Technical Service Bulletin: TSB170078

New Modular Common Rail System (MCRS) Fuel Pumps and External Pressure Relief Valve Service Kits for Gerotor Overpressure Caused by Fuel Filter Plugging: FC2261

Product Affected

- QSK50 CM850 (All Versions)
- QSK50 CM2150 (All Versions)
- QSK60 CM2150 (All Versions)
- QSK60 CM850 (All Versions)

Figure 4, External Pressure Relief Valve Installation Layout.

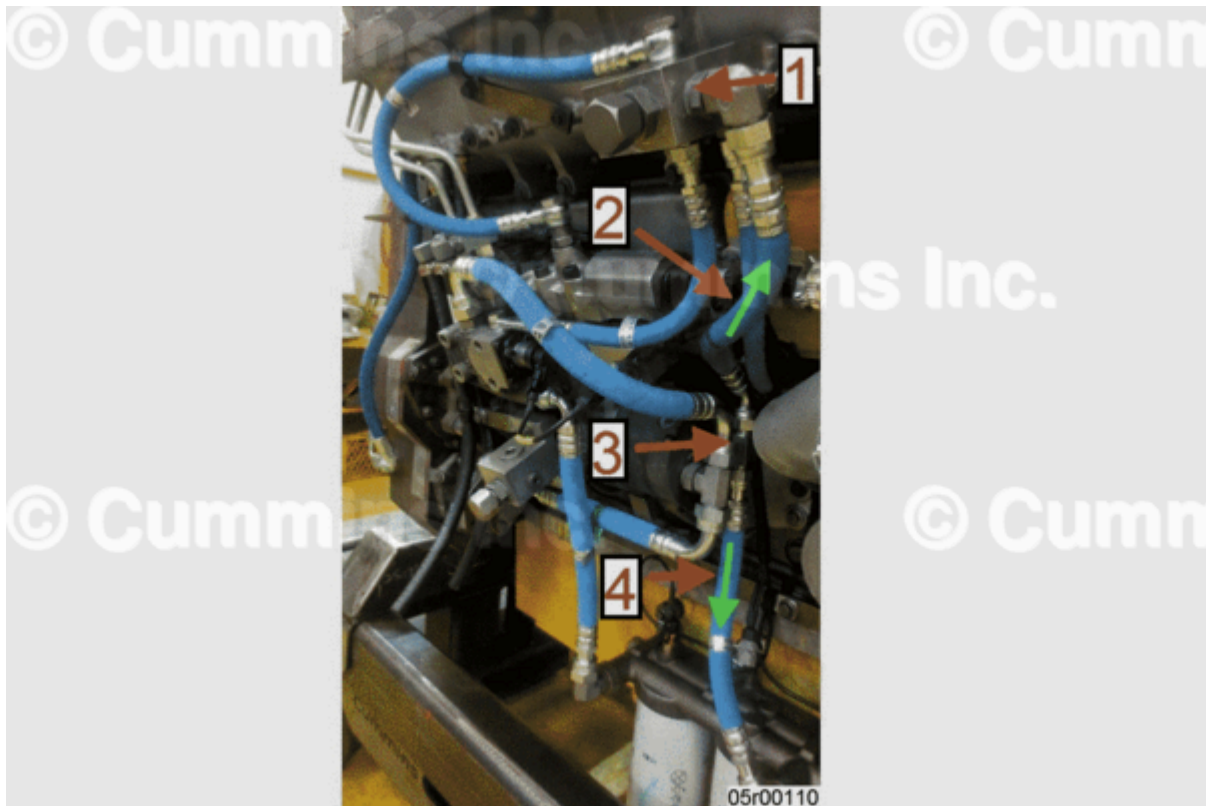
- Install new hose assembly from pressure relief valve normally open outlet to fuel filter head inlet. Elbow hose fitting to fuel filter head **Torque Value:** 95 N•m [70 ft-lb]. Hose to external pressure relief valve **Torque Value:** 65 N•m [48 ft-lb].

- Install new hose assembly from relief valve normally closed outlet to new fuel return block. Elbow hose fitting in pressure relief valve **Torque Value:** 95 N•m [70 ft-lb]. Hose to union in fuel manifold **Torque Value:** 65 N•m [48 ft-lb].
